Model: Model J-P4		Date: 27-Jul-05	No.: RG131001
Subject: Firmware Release History (NIB)		Prepared by: H. Someya	
From: 1st Tech. Support Sec. Service Support Dept.			
Classification:	<input type="checkbox"/> Troubleshooting <input type="checkbox"/> Part information <input type="checkbox"/> Action required <input type="checkbox"/> Mechanical <input type="checkbox"/> Electrical <input type="checkbox"/> Service manual revision <input type="checkbox"/> Paper path <input type="checkbox"/> Transmit/receive <input type="checkbox"/> Retrofit information <input checked="" type="checkbox"/> Other ()

Model: Model J-P4		Date: 10-May-06	No.: RG131009
Subject: LCT Jam or Noise		Prepared by: H.K.	
From: 1st Tech. Support Sec. Service Support Dept.			
Classification:	<input checked="" type="checkbox"/> Troubleshooting	<input type="checkbox"/> Part information	<input type="checkbox"/> Action required
	<input type="checkbox"/> Mechanical	<input type="checkbox"/> Electrical	<input type="checkbox"/> Service manual revision
	<input type="checkbox"/> Paper path	<input type="checkbox"/> Transmit/receive	<input type="checkbox"/> Retrofit information
	<input type="checkbox"/> Product Safety	<input type="

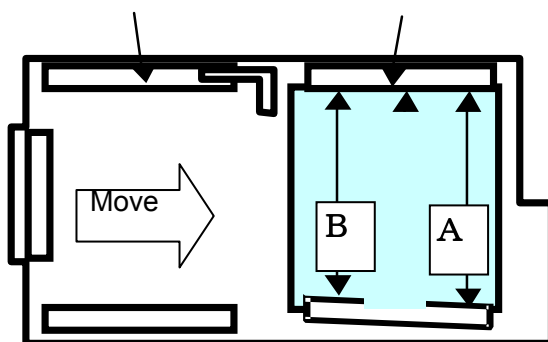
When the paper stack is moved from the left to the right in the LCT, the first sheet of the paper stack in the LCT jams, or noise occurs and the paper is not fed.

- The distance between the side fences is narrow. As a result, the paper is not moved correctly to the right side of the LCT, and the timing belt is overloaded.
- The paper is wider than specification or has burrs on its edge

1. The distance between the side fences was increased by 0.5mm.
 - The length of the front side fence was changed (P/N B1809902)
2. The distance between the side fences is checked on the production line.
 - Cut-in S/N:

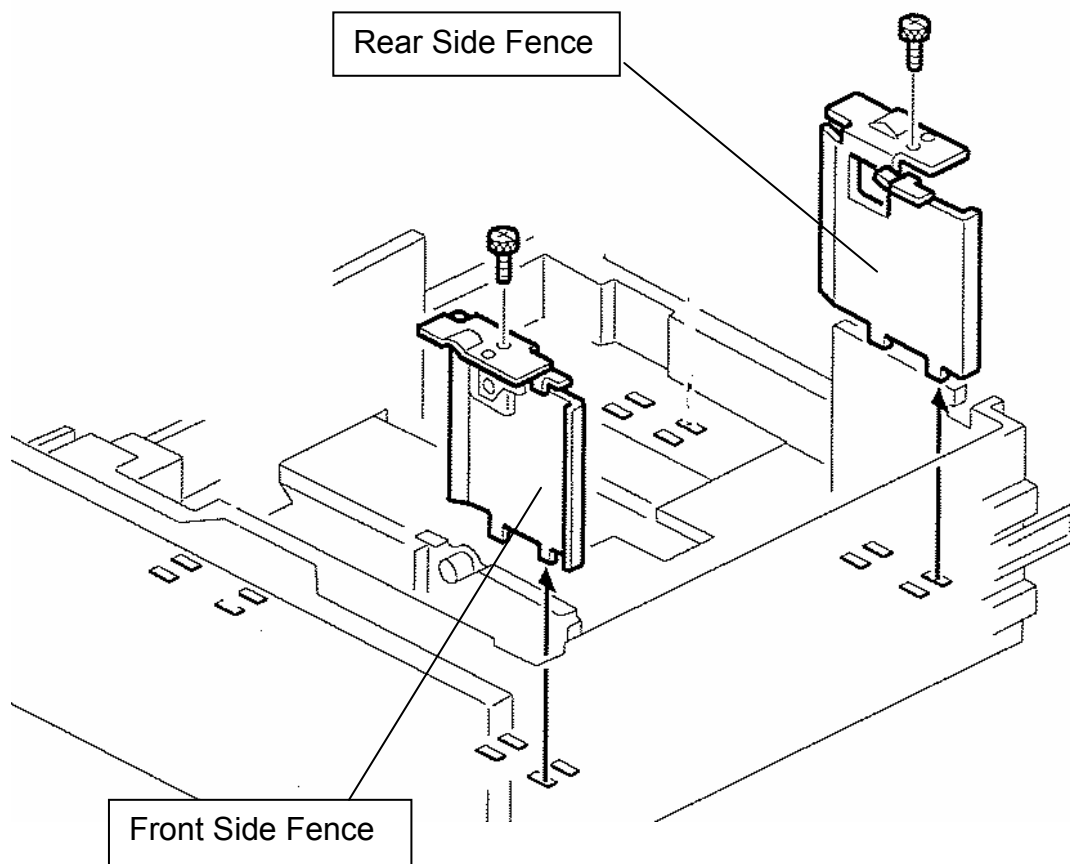
Permanent:

1. The distance between the side fences was increased by 0.2 mm
- The positions of the screw holes were moved 0.1 mm.
2. The distance between the side fences is checked on the production line.

Old part number	New part number	Description	Q'ty	Int
G5692640 (B6002640)	B6002645	FRONT SIDE FENCE	1	X/O
G5692650 (B6002650)	B6002655	REAR SIDE FENCE	1	X/O

1. Replace the front side fence with **B1809902** (production line temporary solution).

2. Replace the front side fence and rear side fence with **B6002645** and **B6002655**.

Fig. 2: The **new** BK drum motor (**AX060340**) is installed.

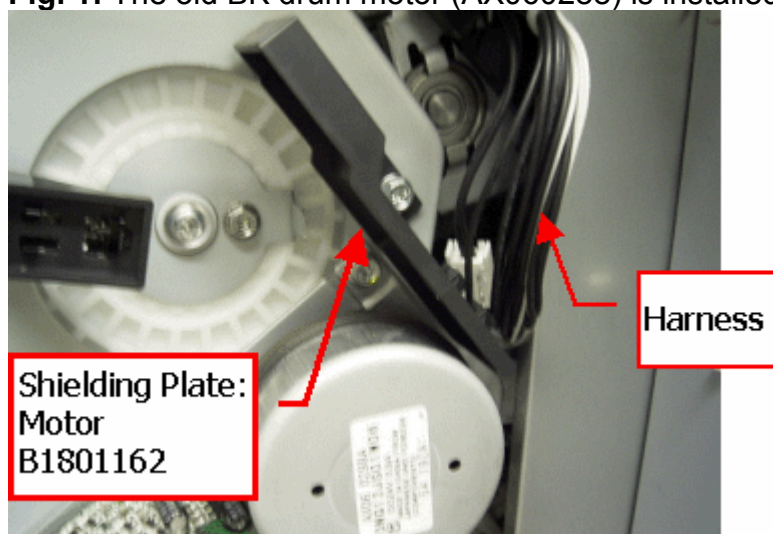
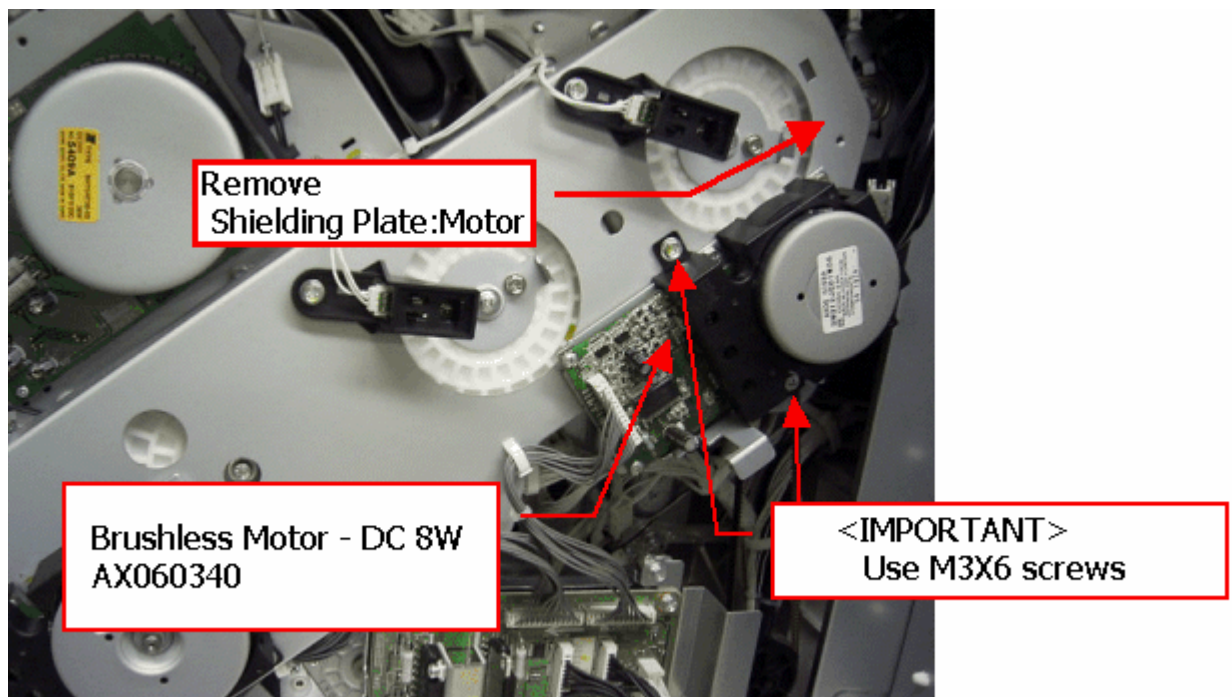
- Only use **M3x6** screws to attach the cover. If you use any other screws, they will touch the drum gear.
- When you attach the BK drum motor (AX060340) for the first time, remove the shielding plate (B1801162) that is already attached.

Fig. 1: The old BK drum motor (AX060288) is installed.
